ADDENDUM NO. 1

**HARDY SCHOOL PLAYGROUND RENOVATION
Arlington, MA**

Bid No. 21-04

January 29, 2021

Drawing Title:
ADD ALTERNATE DELINEATIONS

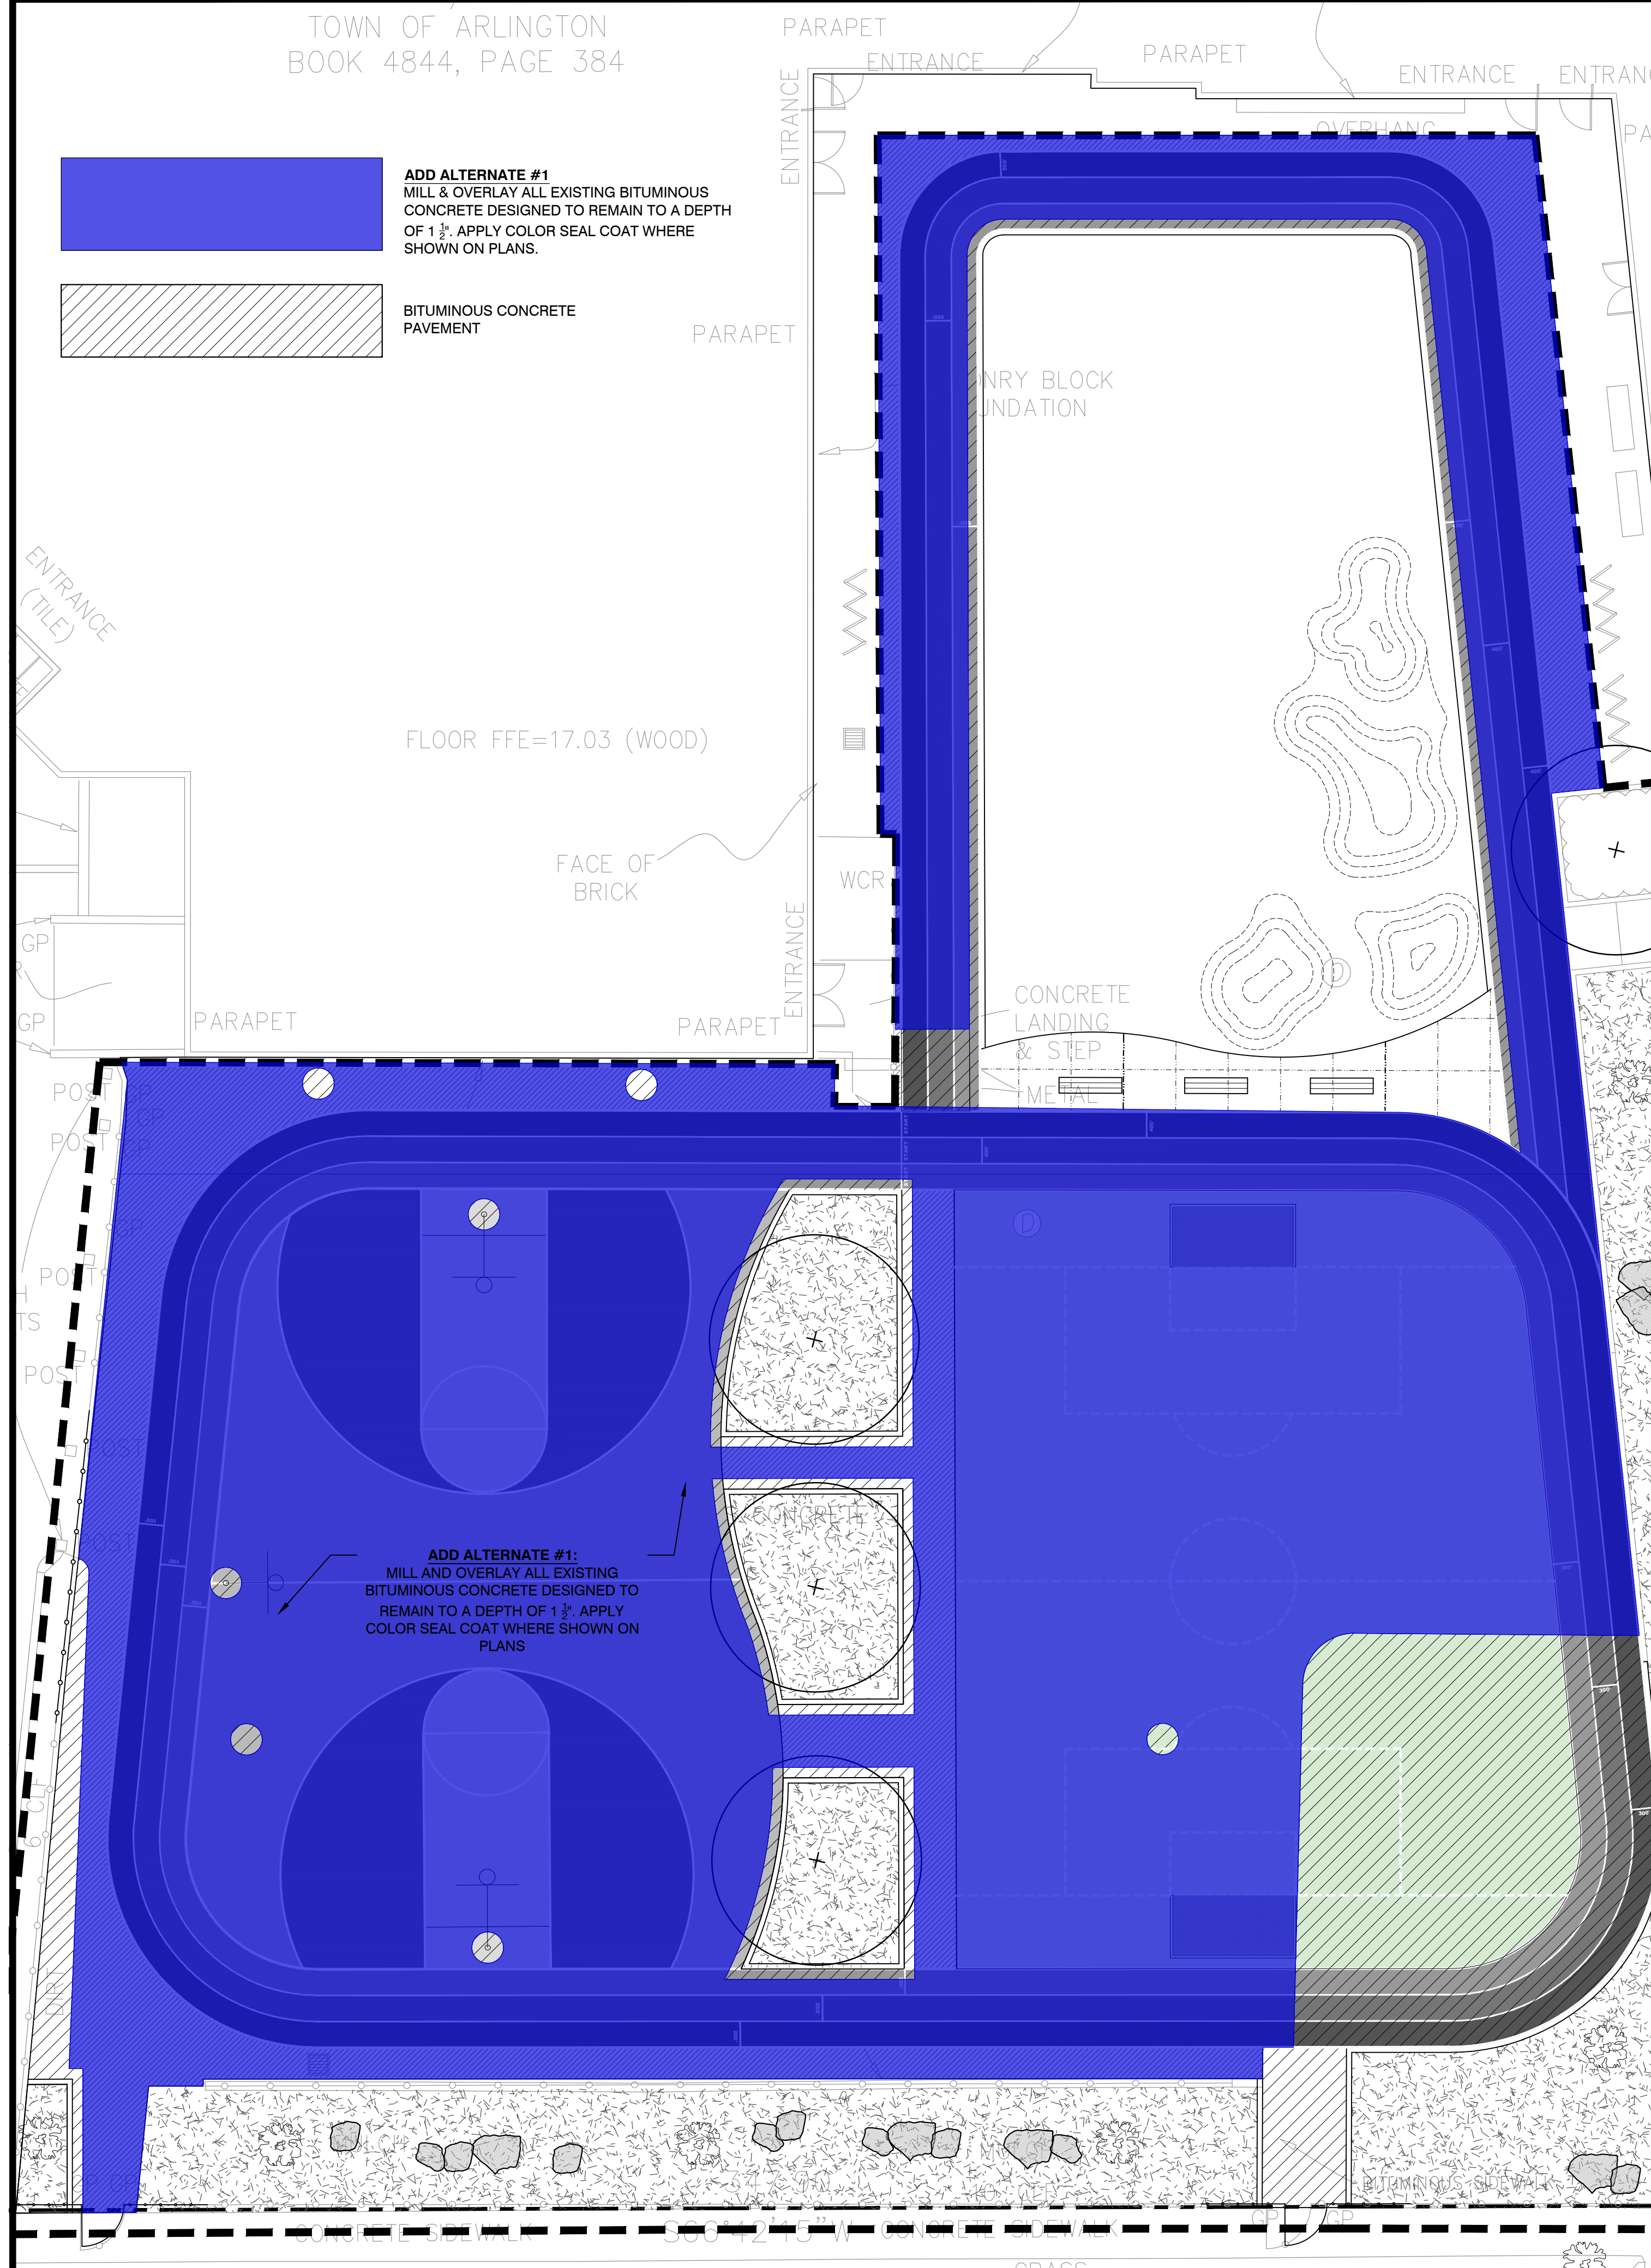
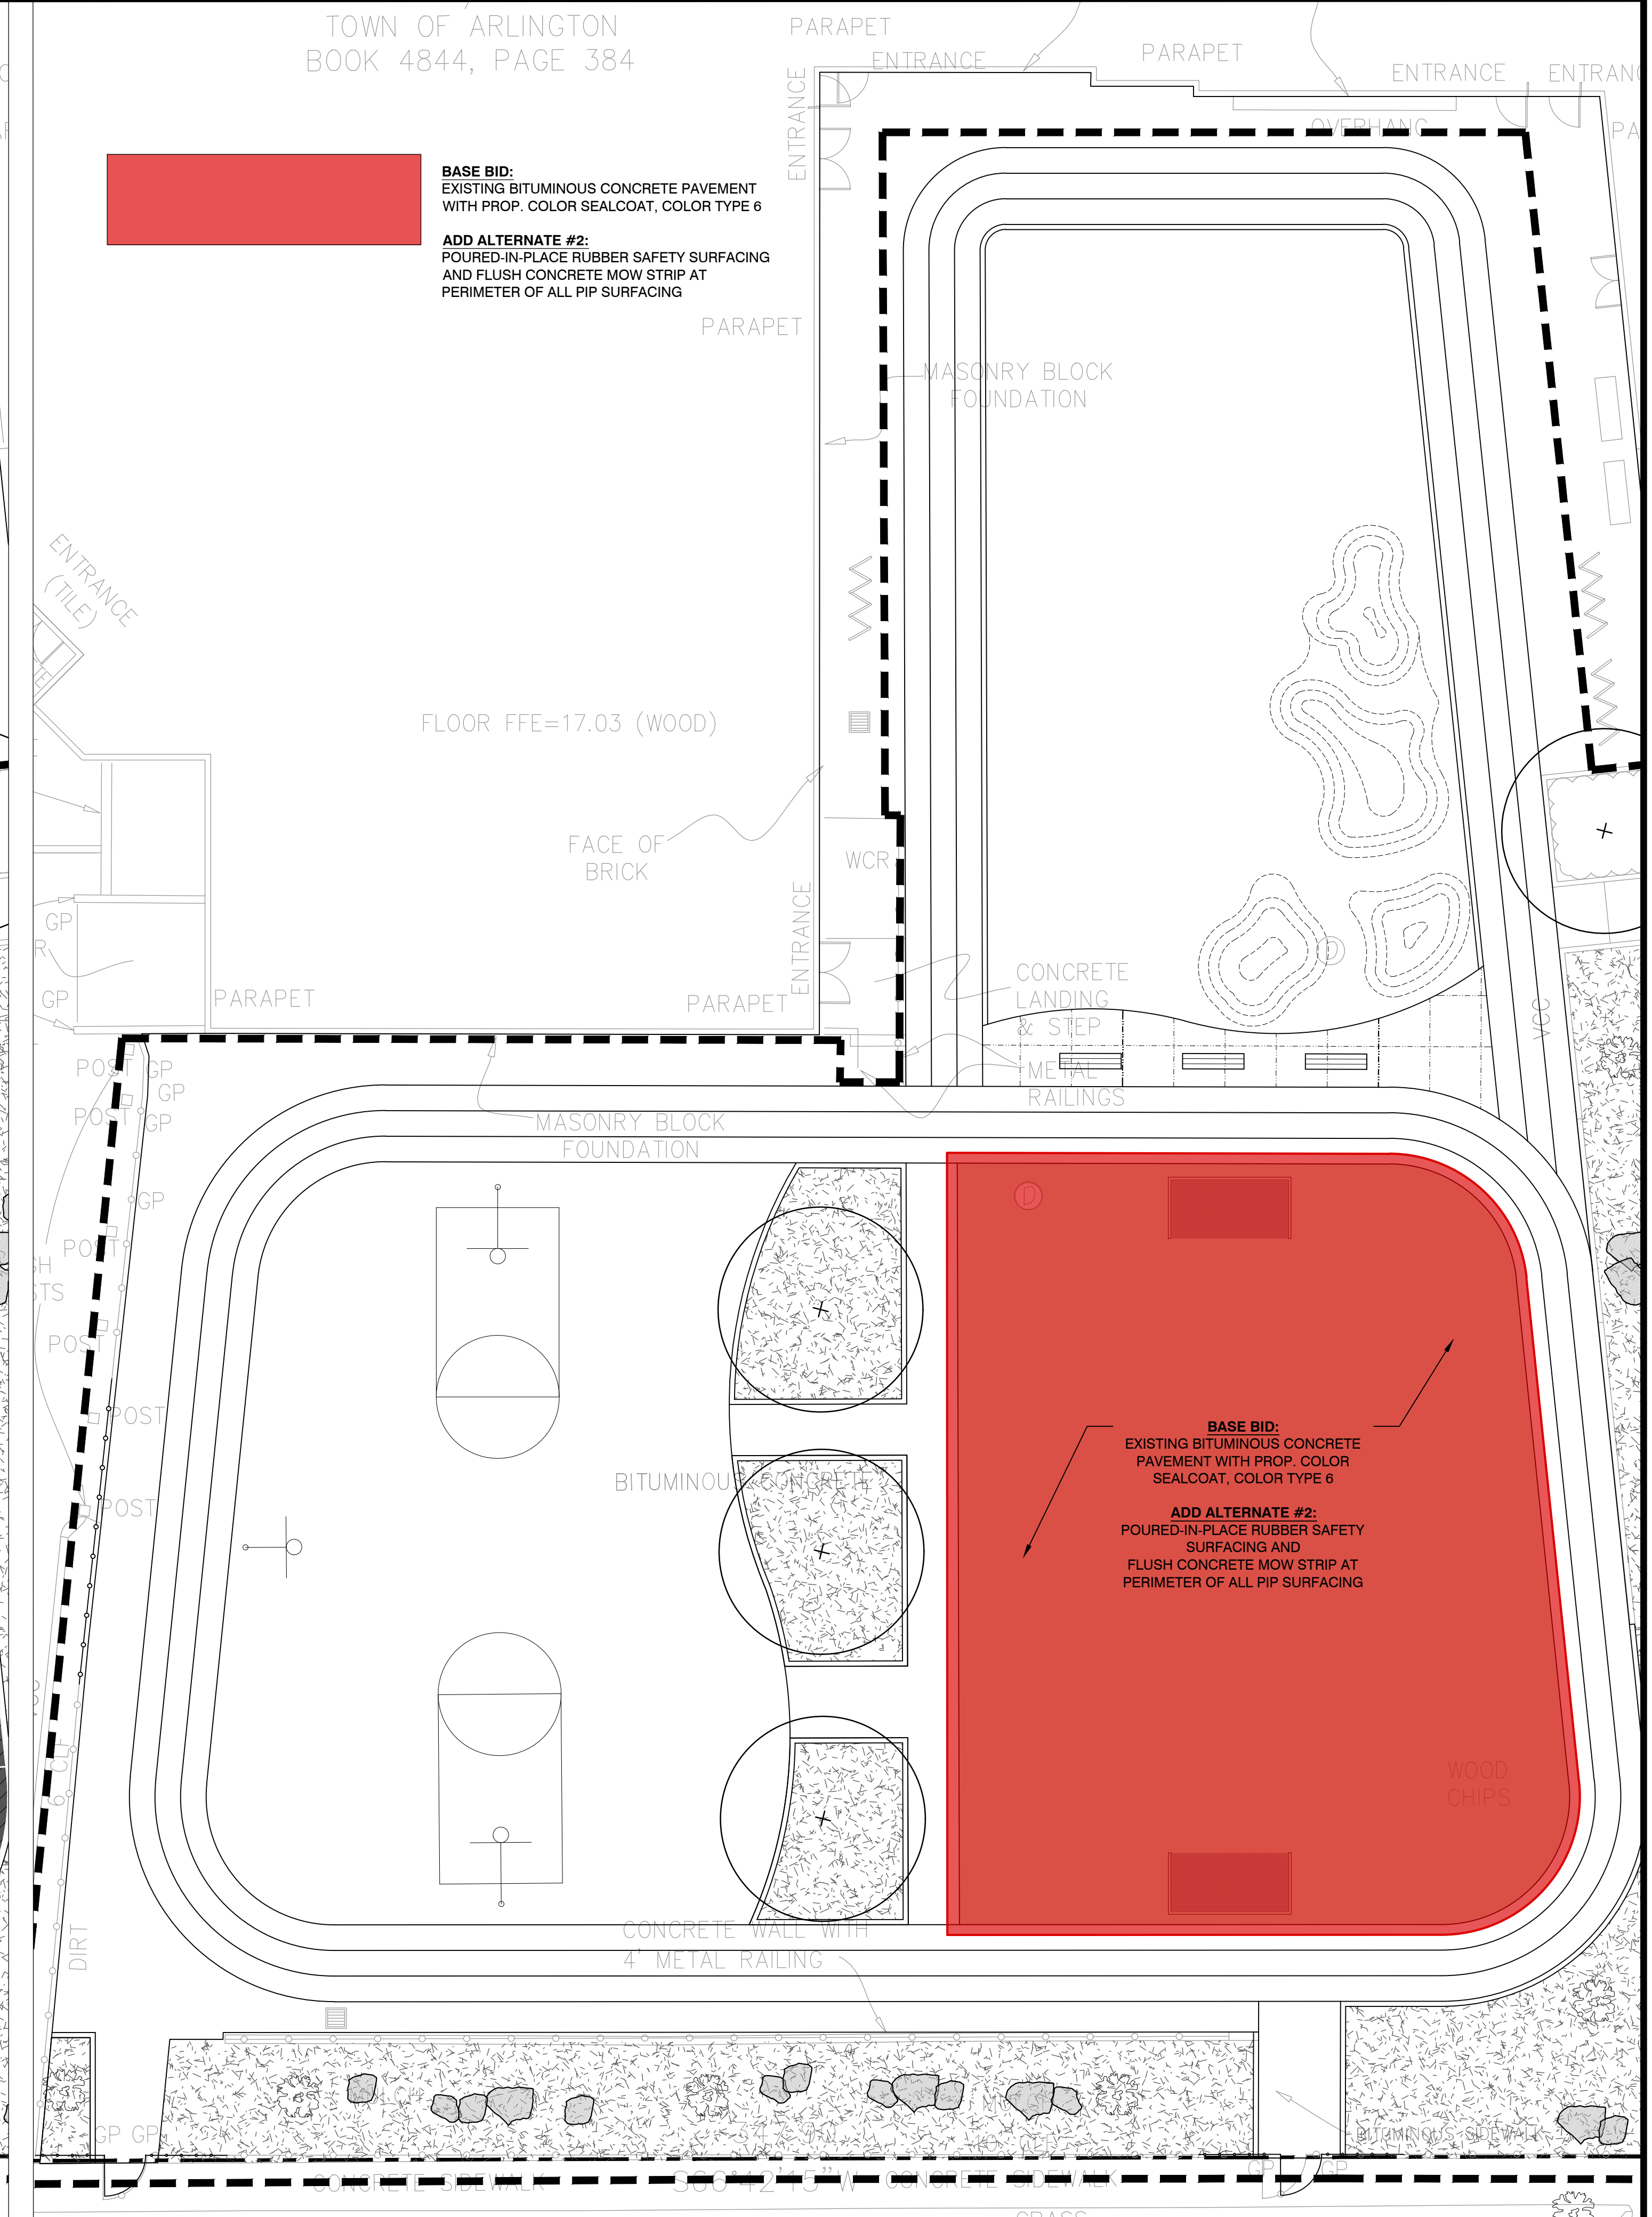
Question 4: Please delineate the exact limits of alternate #1.

Question 8: Please delineate the exact limits of alternate #2.

Question 14: Could you please clarify the area to mill and overlay in add alternate #2. The description says 'all existing bituminous concrete to remain' does this include the area in between the basketball courts and soccer fields and the area around the walking/running track at the new playground area?

Answer: See attachment SK-1 for Add Alternate delineations and note that Add Alternate #1 and #2 have swapped per the written changes noted above.

Answer: Please see attachment SK-1 for Add Alternate delineations. Note that Add Alternate #1 and #2 have swapped per the written changes noted above.

Answer: Now Add Alternate #1, this alternate calls for the top 1 ½” of the existing bituminous concrete to be milled. A new 1 ½” top course will be overlaid on the milled surface. The area between the soccer field and basketball court would be milled and overlaid with exception to the three planting beds, where full depth removal of the bituminous concrete is required. The areas around the concrete curbs at the planting beds will include a new a full depth 1-foot wide bituminous concrete strip to accommodate the installation of the curb. The walking track around the new play area would also be milled and overlaid in the same manner as intended for the mow curbs around the planting beds.

ADD ALTERNATE #1
MILL & OVERLAY ALL EXISTING BITUMINOUS CONCRETE DESIGNED TO REMAIN TO A DEPTH OF 1 3/4". APPLY COLOR SEAL COAT WHERE SHOWN ON PLANS.

ADD ALTERNATE #2:
POURED-IN-PLACE RUBBER SAFETY SURFACING AND FLUSH CONCRETE MOW STRIP AT PERIMETER OF ALL PIP SURFACING
